DESCRIPTIVE REPORT

Field No. ST-2154 Office No. H-8168

Locality Vicinity of Matinicus Island

REVIEW OF HYDROGRAPHIC SURVEY

Overlay #1

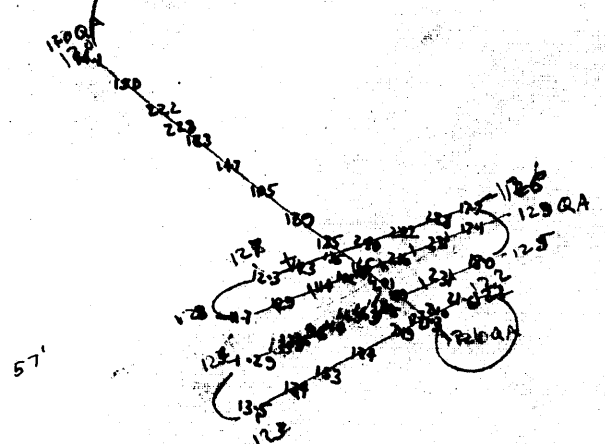
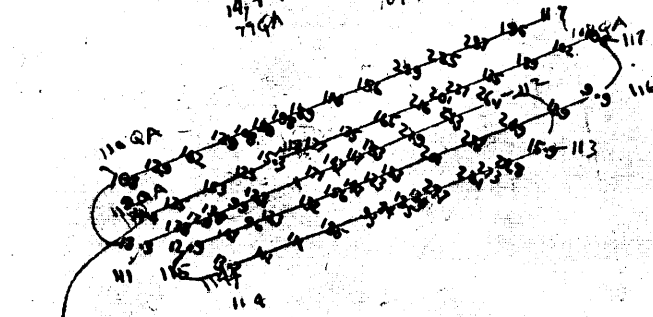
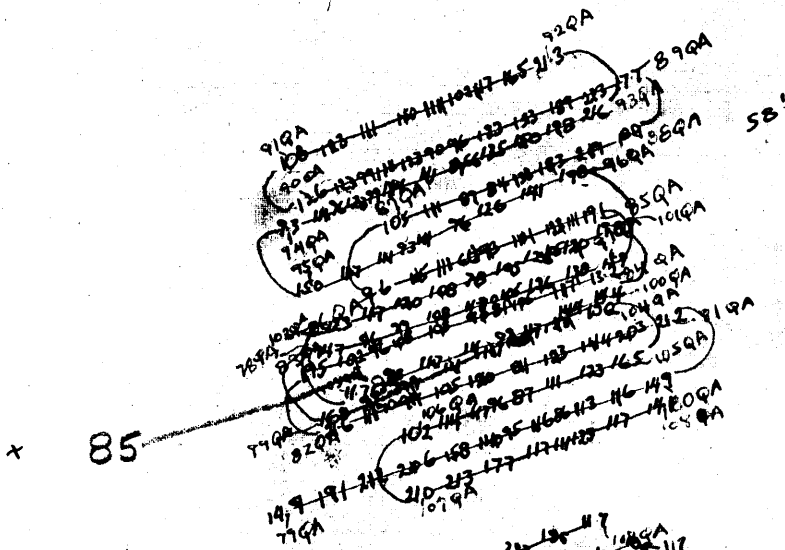
The following positions were plotted on an overlay to accompany the smooth sheet:

79 to 92W, 81 to 82QA, 99 to 100QA and 103 to 104QA
